U.S. NUCLEAR REGULATORY COMMISSION
REGION I

Docket/
Report No. 50-213/93-22

Facility: Haddam Neck Plant

Dates: December 12, 1993 to January 15, 1994

FIGURE 1. WASTE GAS SYSTEM

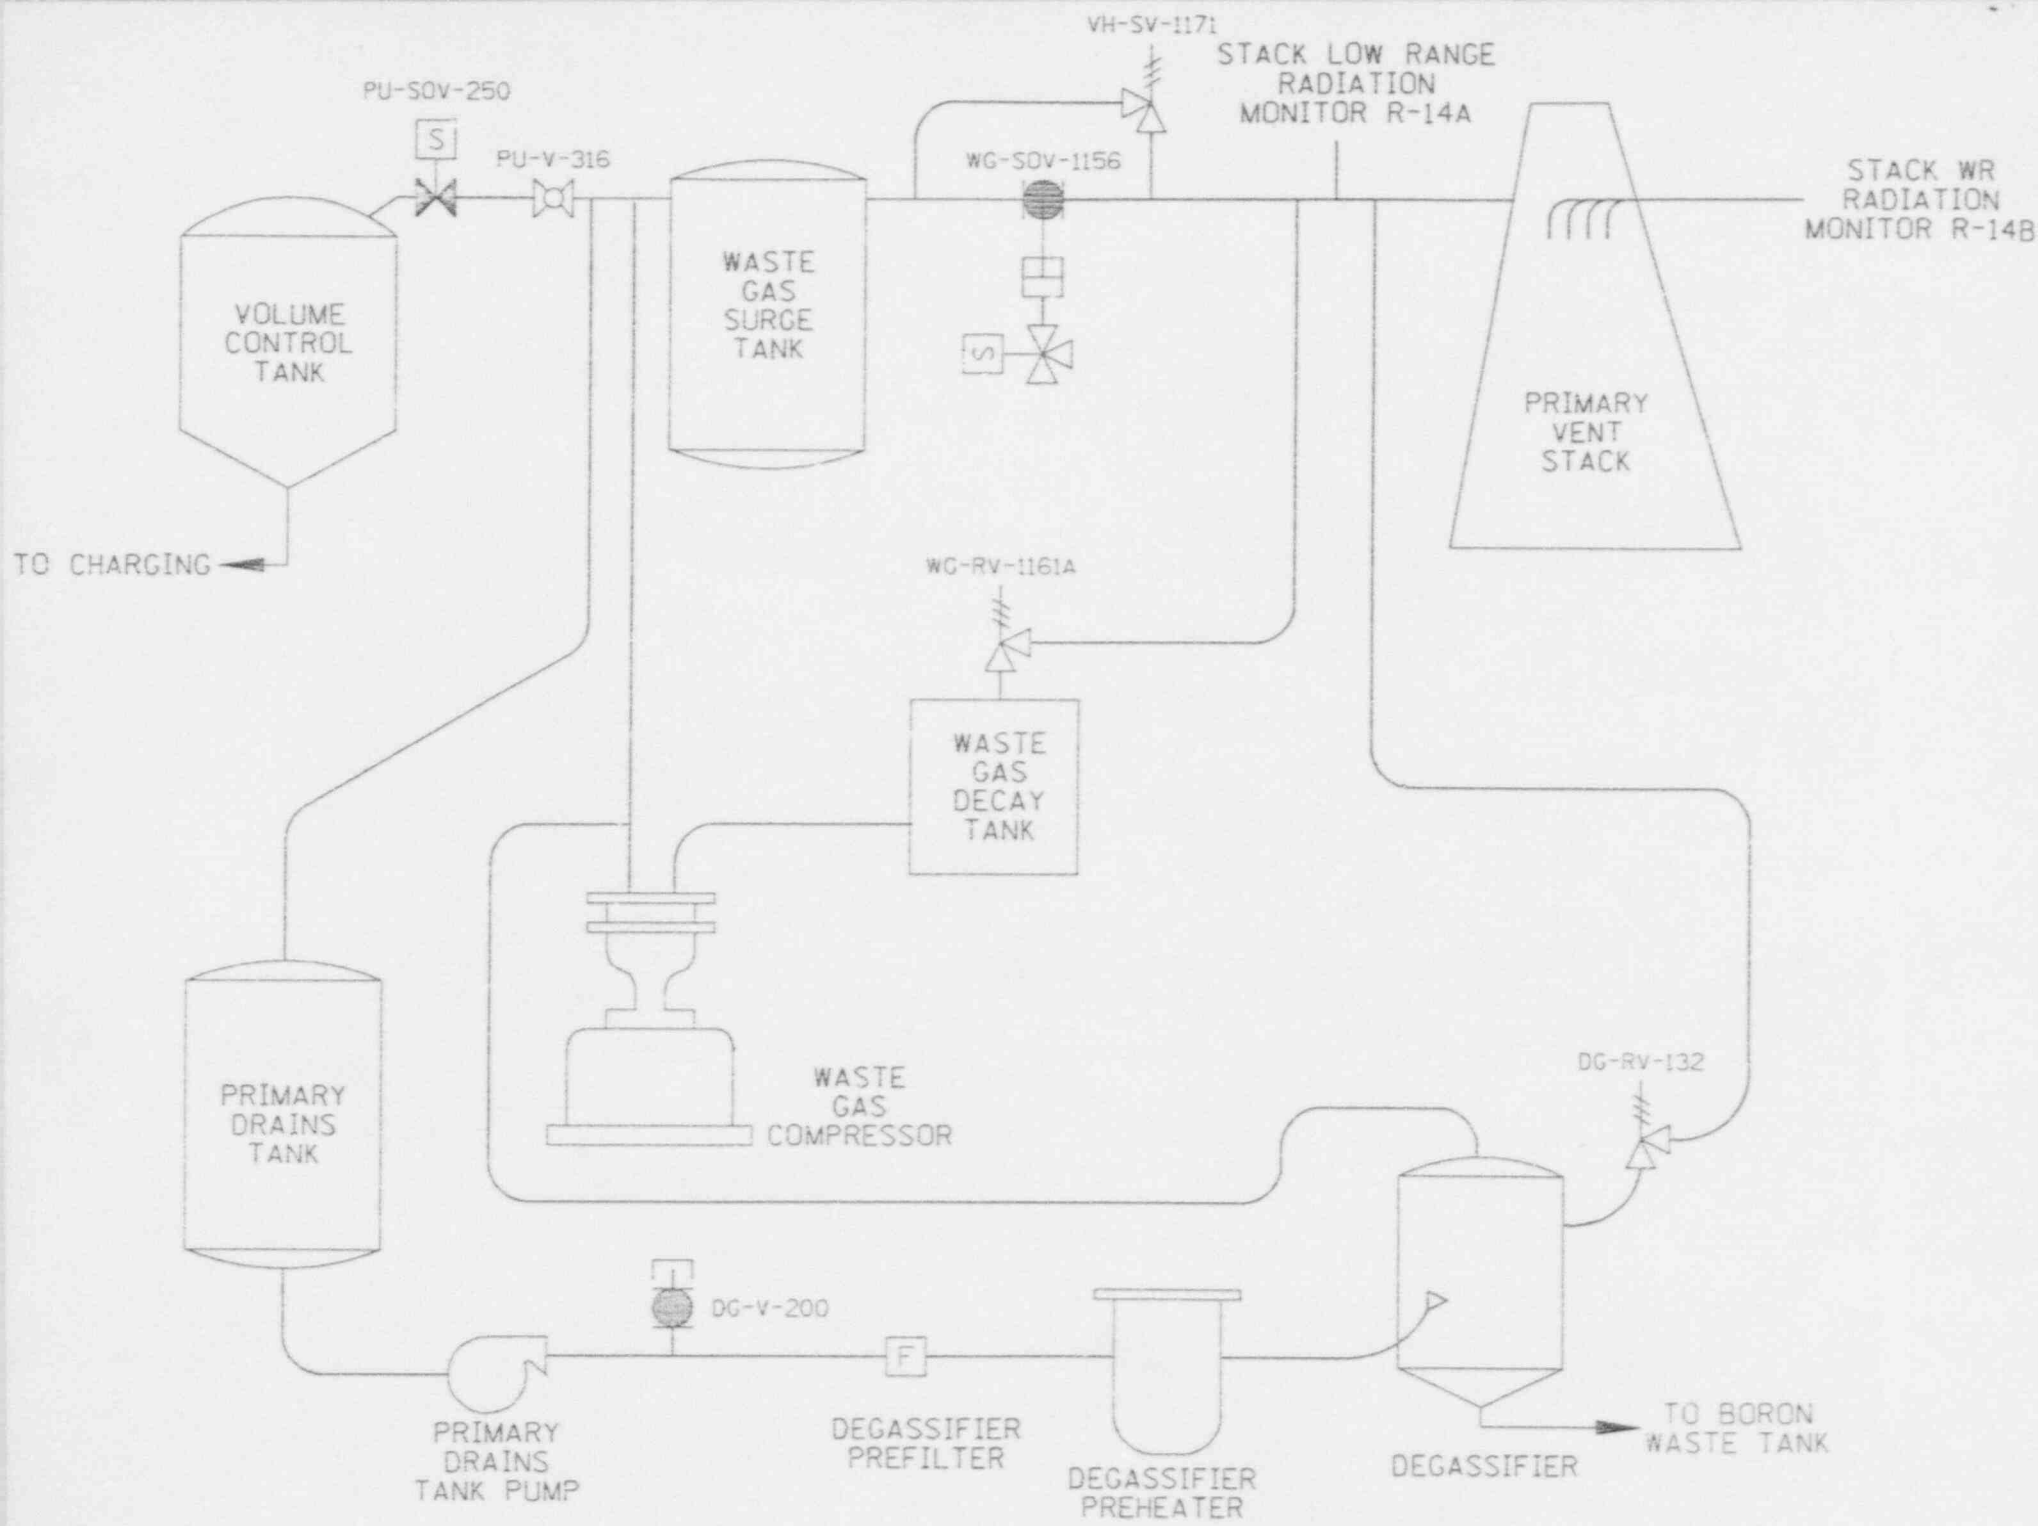
The licensee performed an immediate investigation of the event to determine how the release occurred and its causes. The inspector observed the licensee activities and independently confirmed the event sequence and causes. The release occurred as the VCT was being vented. The release path was from the VCT to the waste gas vent header to the waste gas surge tank to the waste gas relief line to the primary vent stack (see Figure 1). The licensee concluded that the relief valve on the waste gas vent header of the waste gas surge tank had lifted prematurely.

Although PU-SOV-250 was left open longer than intended during the venting operation, this action alone did not cause the unplanned gas release. The waste gas system is designed to operate assuming an open path from the VCT to the waste gas system. VCT valve PU-V-316 is throttled to limit the flow rate from the VCT into the waste gas vent header. The licensee's followup investigation confirmed that PU-V-316 was one turn open, as required. Waste gas compressors C-13-1A and 1B start automatically when the pressure in the waste gas header reaches 1.5 psi and 2.0 psi, respectively. Both compressors operated as expected during the event. The setpoints on the relief valves located both on the suction and discharge sides of the compressors are set to allow sufficient margin to the normal operating pressure in the header, as follows: VH-SV-1171 is set at 20 psig; WG-SOV-1156 is set at 14.5 psig; DG-RV-132 is set at 65 psig; and, WG-RV-1161A-D are set at 225 psig. However, the pressure in the waste gas header and the waste gas surge tank only reached about 4 psig during the release. The licensee concluded that one of the relief valves had misoperated and lifted prematurely. The initial investigation focused on valves WG-SOV-1156 and VH-SV-1171.

- The solenoid operator for waste gas surge tank relief valve WG-SOV-1156 was tested and found to operate satisfactorily at the prescribed lift setpoint of 14.5 psig. Thus the mechanical relief valve (VH-SV-1171) on the waste gas surge tank was the likely malfunction causing the release. The licensee plans to test this valve, but deferred that action until system conditions allow isolation of the tank.
